CERTIFICATE OF APPROPRIATENESS

Property: 1139 Peddie Street, Lot 11, Block 108, North Norhill Subdivision. The property includes a historic 1,092 square foot, one-story wood frame single-family residence and detached garage situated on a 5,000 square foot (50' x 100') corner lot.

Proposal: Project Type – Construct a rear one-story addition to an existing one-story residence.

Recommendation: Partial Approval:

FIRST FLOOR PLAN

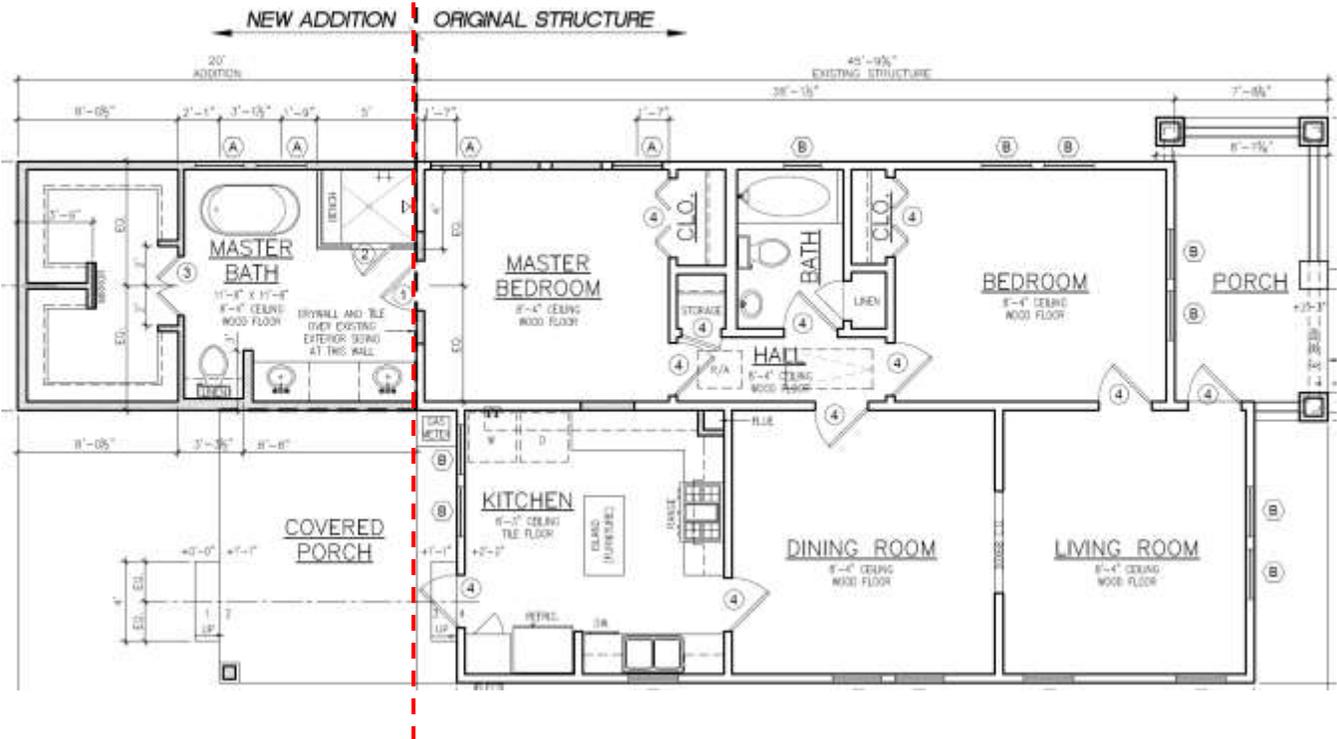
Windows/Doors: The residence features original wood 1-over-1 sash windows and an original entry door; the original windows and entry door will be retained. A pair of 1-over-1 sash windows on the east elevation will be split and relocated on the east elevation to accommodate an interior bed wall. A pair of original 1-over-1 sash windows on the rear elevation will be relocated to the east elevation of the proposed addition.

Denial of the splitting and relocation of an original pair of 1-over-1 sash windows on the east elevation.

SIDE (EAST) ELEVATION

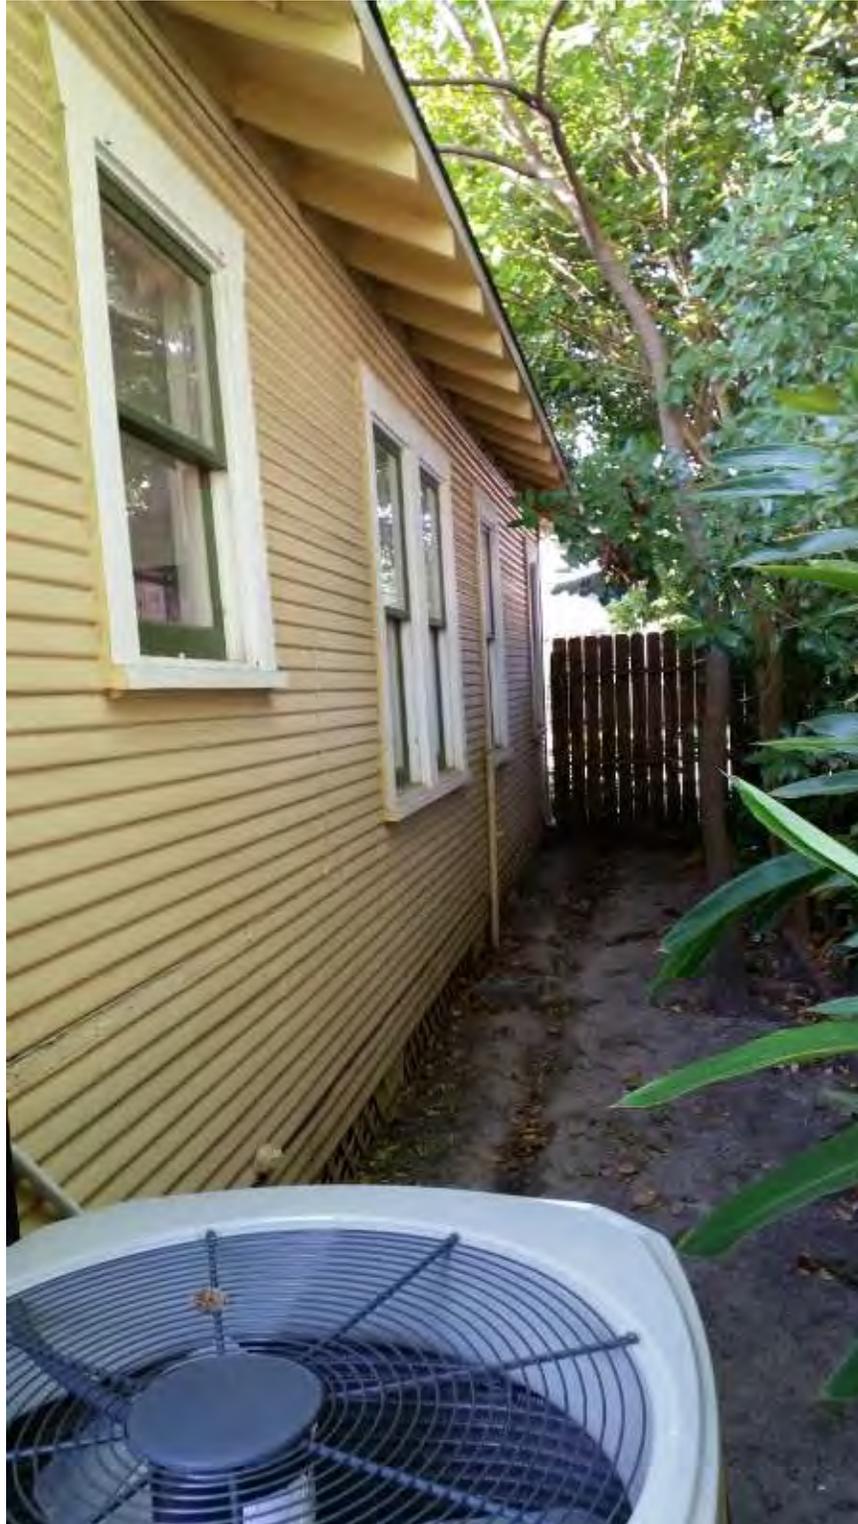
<i>The splitting and relocation of the original pair of 1-over-1 sash windows on the east elevation alters the fenestration pattern on the east elevation and requires that new openings be created to accommodate the new window locations which results in the loss of significant historical material.</i> |

<i>The splitting and relocation of the original pair of 1-over-1 sash windows on the east elevation alters the fenestration pattern of the 1928 Bungalow. The relocation of the two original windows results in the loss of significant historical material as a result of the new window openings on the east elevation.</i> |

ORIGINAL WINDOWS TO BE SPLIT & RELOCATED
